SUBJECT: Forwards request to NRC 980716 RAI re GL 96-06, "Assurance of Equipment Operability & Containment Integrity During Design Basis Accident Conditions."

Re: Turkey Point Units 3 and 4
Docket Nos. 50-250 and 251
Response to Request for Additional Information
NRC Generic Letter 96-06, Assurance of Equipment
Operability and Containment Integrity During Design
Basis Accident Conditions (TAC Nos. M96878 and M96879)

RESPONSE TO REQUEST FOR ADDITIONAL INFORMATION -
GENERIC LETTER 96-06

TURKEY POINT CONTAINMENT COOLER CONFIGURATION HEADER A SCHEMATIC

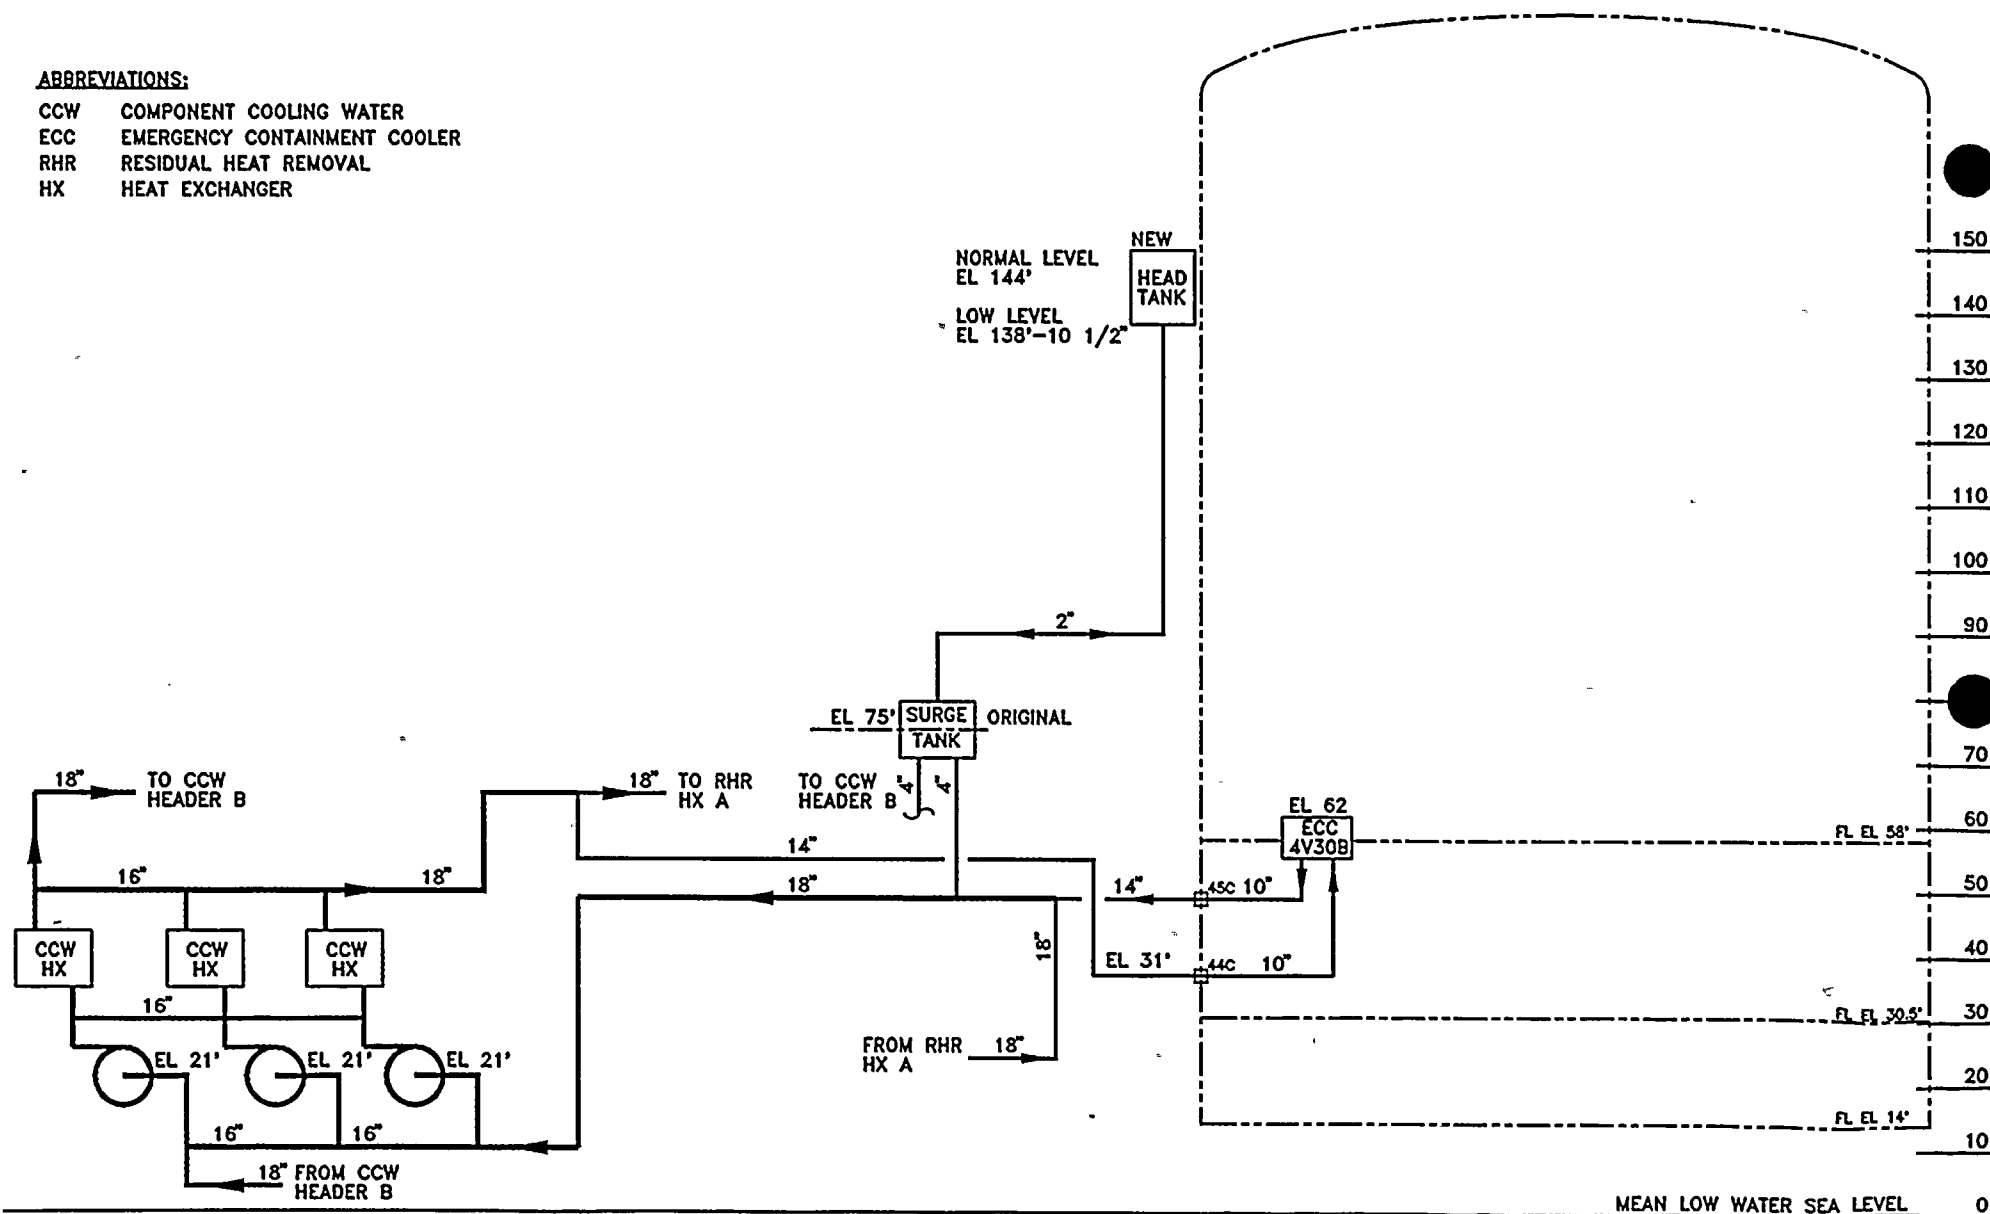
9. Provide a simplified diagram of the affected system, showing major components, active components, relative elevations, lengths of piping runs, and the location of any orifices and flow restrictions

A diagram is provided as Attachment 2.

The modifications consist of the installation of new safety-related head tanks to passively maintain the containment air coolers subcooled during a postulated worst case LOOP/LOCA event. The new head tanks have been seismically mounted on the side of the containment structures at an elevation of 138' - 3" (bottom of tank). The Unit 3 Emergency Containment Cooler (ECC) 3CV30A is the high point cooler at an elevation of 73 feet (73.5 feet is used for conservatism). The elevation of the head tank is based on achieving a minimum of 27.1 psig static pressure in this cooler in the event that stagnant conditions exist as postulated for the event of concern. For conservatism, the pressure resulting from the head tank static water column outside containment was based on a saturated water density at 200°F (expected < 100°F). A detailed review of all affected components was performed to ensure that this increase in pressure was acceptable. As a result of the study, several relief valve set point changes were revised and the excess letdown heat exchangers were rerated. The surge tank relief was designed with the lowest system setpoint to ensure that no other relief valves located inside containment would lift prior to this relief valve. This feature ensures that the CCW System will not drain during a postulated over-pressurization event assuming that the relief valve does not reseal.

The new head tanks can be considered an extension of the original surge tanks. The head tanks were tied to the existing surge tanks via the original surge tanks' vent line. Piping to this vent line now extends from the surge tank to the new head tank. The new head tank vent ties back into the original vent line which extends to the waste holdup tank. This line includes a control valve that was originally designed to isolate on high activity. The logic of this valve was changed to also include closure on high level to reduce the possibility of overfilling the tank during filling operations. The new head tanks have been designed with the same operating band volume as the original surge tanks and with independent instrumentation equivalent to the existing surge tank instrumentation. Appropriate control room annunciation has been provided.
